Re: Park Master Plan for 4809/4819 Vermack Rd.

### Vermack Rd Park Property December 10, 2022 Open House Comments

# Vermack – Draft Master Plan

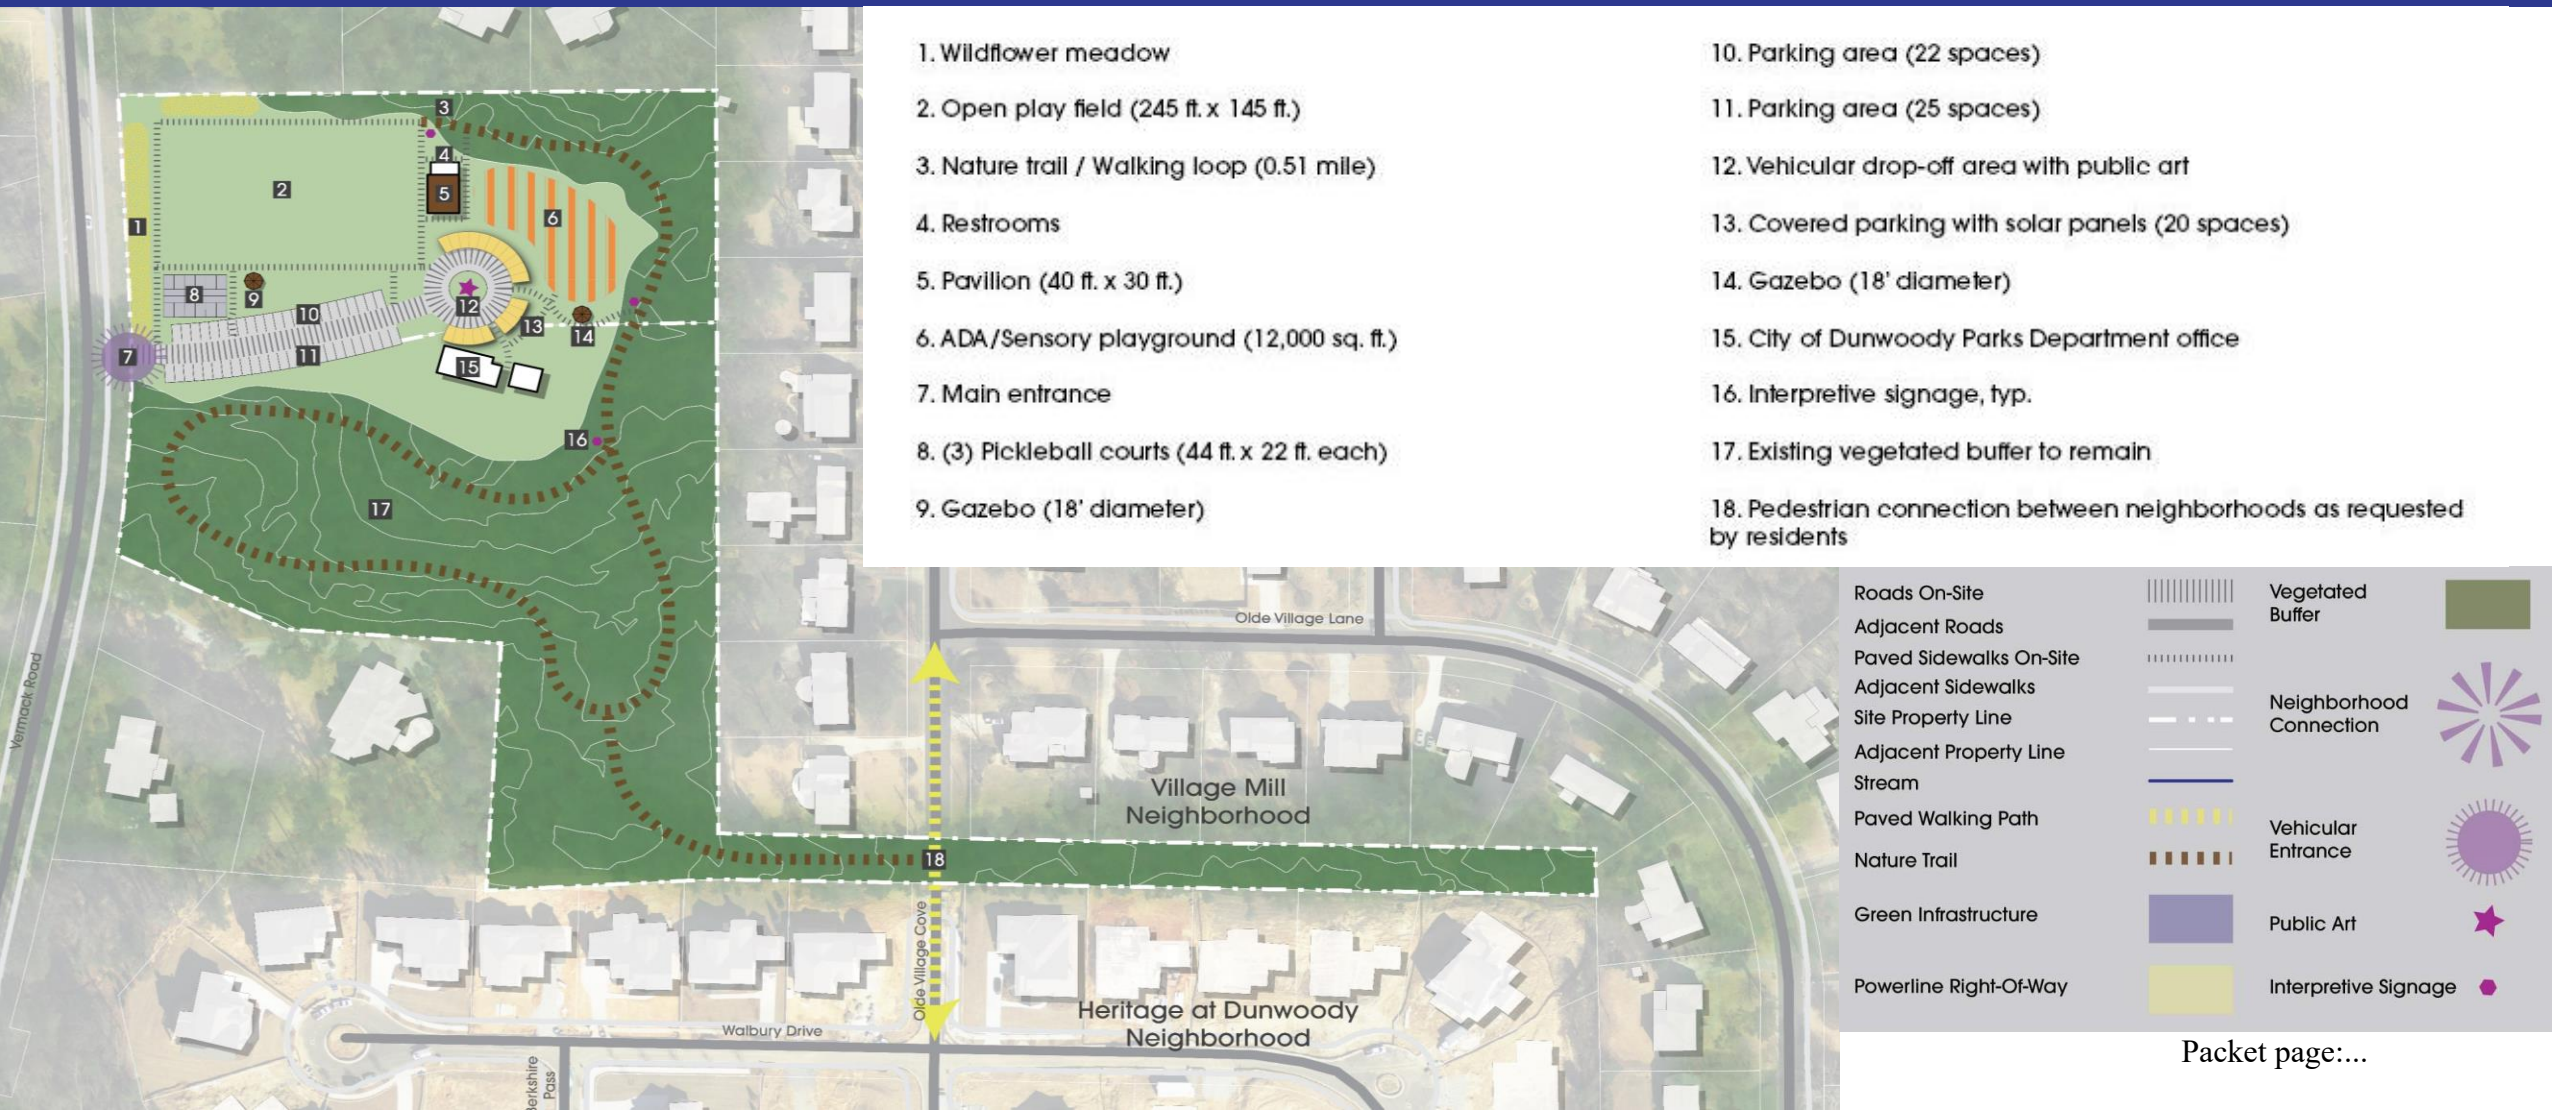
- As I have stated in all my previous comments/ concerns. The paved road/parking will substantially increase water drain off and cause flooding in village mill of already burdened water runoff drains it will be worse if the play fixtures get artificial turf.

- do not tear down brick or other house!
- Nature trail. Wildlife habitat has been lost due to heritage home subdivision. How about a traffic calming island in front of park. no parking lot.

- Crosswalk at P and Vermack Rd. Get it to flash.
- Get rid of feature #18, no path from heritage Dunwoody through to village mill neighborhood. Put up speed notification lights by park to alert drivers going too fast. Finish cross walk on West side Vermack Rd.

- We would like a fence around the park. We live next to the space that is designated to be open field #2 and we do not want people to walk straight into our backyards.

- We think there are too many parking spaces allocated. Too much exhaust and noise.
- I think 655 out of 655 for the nature trail. That means I really like it love McKenna Buckley age 7.

- fencing on Vermack Rd.
- Please leave the trees in the playground area!
- Against the path. Hate the number of parking places. Create a buffer zone of at least 40 feet from neighbors. Deal with the water problem.

- I approve of a long trail between heritage and village mill.
- too many parking places.
- the open playfield needs to have a fence between it and Vermack Rd. For safety

- More trees (and native plantings as screens) less parking. (unnecessary for a passive park, unless it's to be used as overflow Parking for the farmhouse events. Put that on the table that is the intent for this many spaces and the number of spaces will likely have more support. Thank you for wading through the many strong opinions and your consideration of neighbors.

- I like the idea of the Native American signage history. Definitely would want walking trail. Garden green space.
- Too much parking. Windwood hollow is 11 acres and only has 16 spaces. Vermack park is 9 acres and has 67. That's more than the Nature Center. Please look at community garden planters versus a playfield.

- All parking should be on the right of the current driveway.
- I understand the privacy concerns of the heritage subdivision residents that border the "Panhandle" strip, but a natural footpath will develop as other residents in the area walk to the new park. Can we just let it be an undeveloped footpath without concrete hardware etc. Native.

- We love the full connectivity to village mill. This will be a great amenity and the cut through makes it accessible. Thank you for this vision.
- I feel the pickleball court is too close to the road and does not show a green low buffer for residents driving down the street each day. This would not be attractive to look at. I suggest moving the court back some of the road and having plantings (low for security issues) to soften the fencing.

- Please do not add path on the 48 ' wide property between both subdivisions. There would be no privacy.
- Red House should become the loom house. Perfect for Chattahoochee handweavers guild. Spruill will be happy that Chattahoochee is no longer at Dunwoody Community Center.

- Have parking off to side. More green space please. less ball fields please.
- Love the trail idea. Love the connectivity.
- Prefer not to have the path to olde village Cove. Fill the 48 foot area with heavy evergreens.
- Thank you for the path.
- I want the trail and the community garden.
- Please remove the connected path behind homes.
- too much parking please remove some of the spaces. I like the trail.
